Project	IEEE 802.16 Broadband Wireless Access Working Group < http://ieee802.org/16 >	
---------	--	--

Title	Effective utilization for packing and fragmentation subheader	
-------	--	--

Date Submitted	2004-05-10	
----------------	-------------------	--

Abstract	This contribution is to propose the effective packing and fragmentation algorithm.	
----------	--	--

Figure 1 "Packing information within a single MAC PDU"

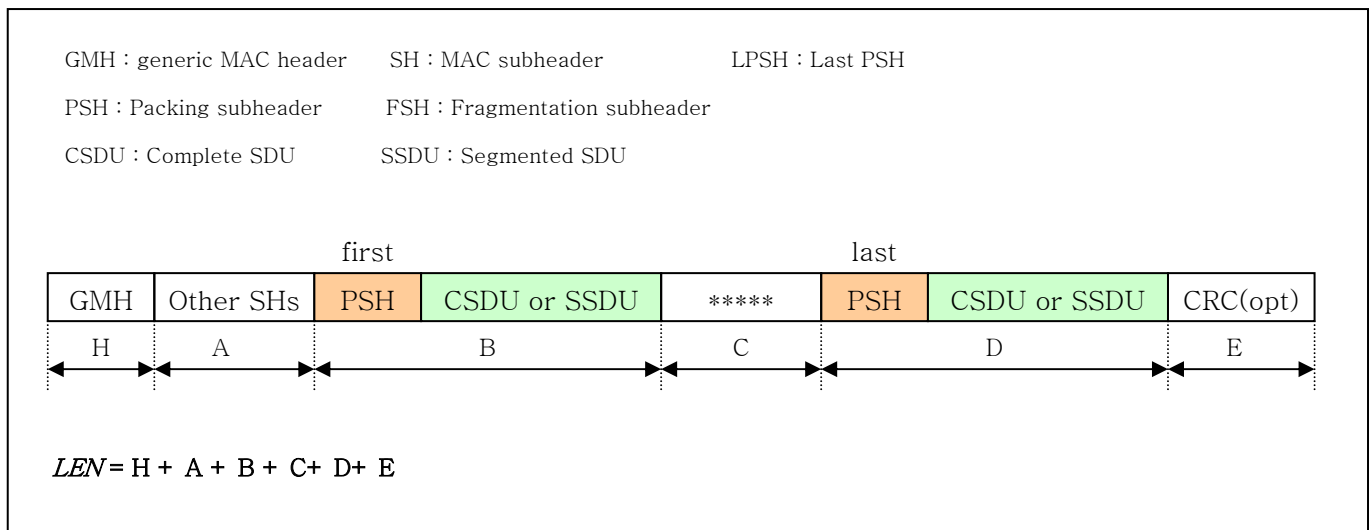
In figure1, all of the PSHs within a single MAC PDU contain 11bits 'length' field. This 'length' field is used for addressing individual beginning of each CSDU/SSDU within the same MAC PDU.

Problem is the 'length' field in the last PSH within a single MAC PDU. Receiver can calculate the size of the last CSDU/SSDU without the corresponding PSH's 'length' field. Therefore, when fragmentation and packing are allowed within the same MAC PDU, the last packing subheader in that MAC PDU can be replaced with an appropriate fragmentation subheader.

The only per-SDU subheader is the Packing subheader. It may be inserted before each MAC SDU if so indicated by the Type field. Packing and Fragmentation subheaders may also be used in the same MAC PDU. When Fragmentation subheader and Packing subheaders are allowed within the same MAC PDU, the last packing subheader in that MAC PDU can be replaced with an appropriate fragmentation subheader.
